工程指示 / 要求簡箋(E.I.)

工程指示編號：EI / 2821 / 20 修改版次：-  
工程編號：J - 852 工程名稱：亞皆老街中電  
工程項目：幕牆 Mockup 用玻璃 B.M. (5/F) T3 (9 件)

收件人：Maggie 發件人：Ant Yeung 日期：14/12/2020

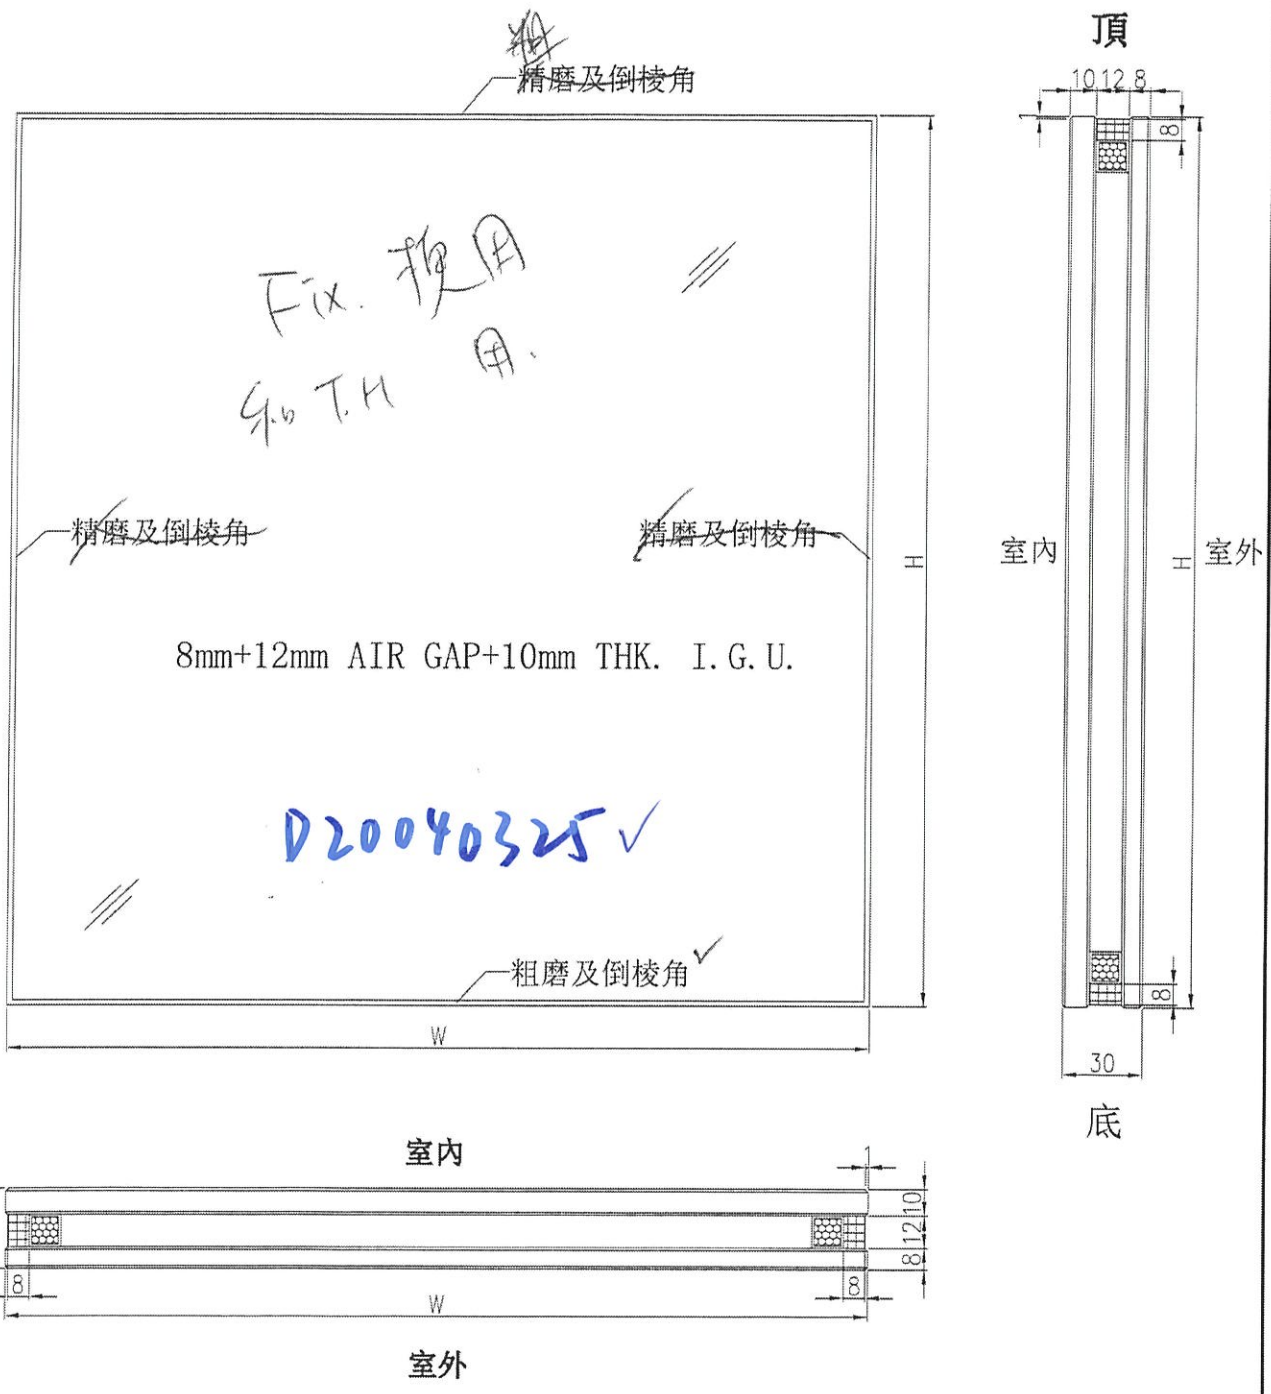
按業主要求，所有 Low-E 玻璃的 SC 為 0.68 (與 EI2782 相同)。所有玻璃尺寸沒有更改。

1. Low-E: 8SEE0-83T; 2. HS: 70T 反光片

8SEE0-83T(HS)+12(A)+10CB 原先編號由 D20070681 改為 D20040325

玻璃要做 Heat Soak

IGU 膠用 DC983

SC=0.68

美特鋁質 MIDI Aluminium Fabricator Ltd.	類別	物料號		
	制圖	LHR	2020-09-09	圖號 GL05-01
修改		復核		數量 —
日期		批准		位置 幕牆樣辦層

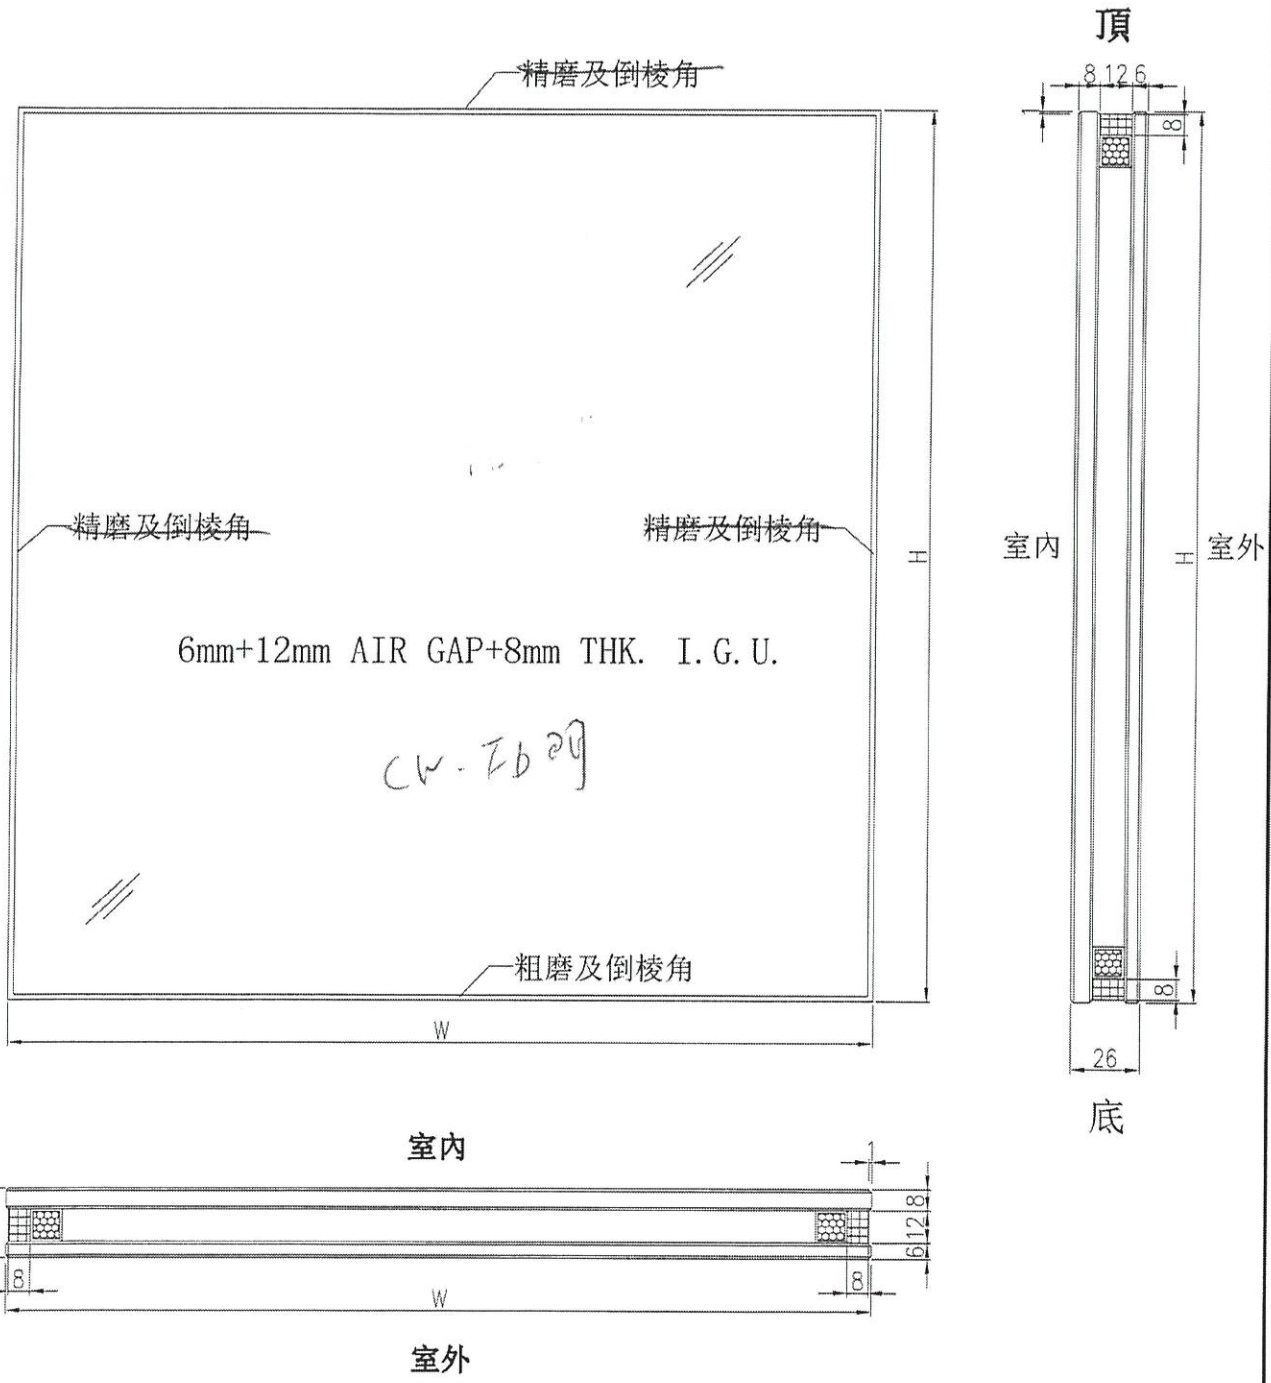
LowE ⇒ SEE 0-83T.
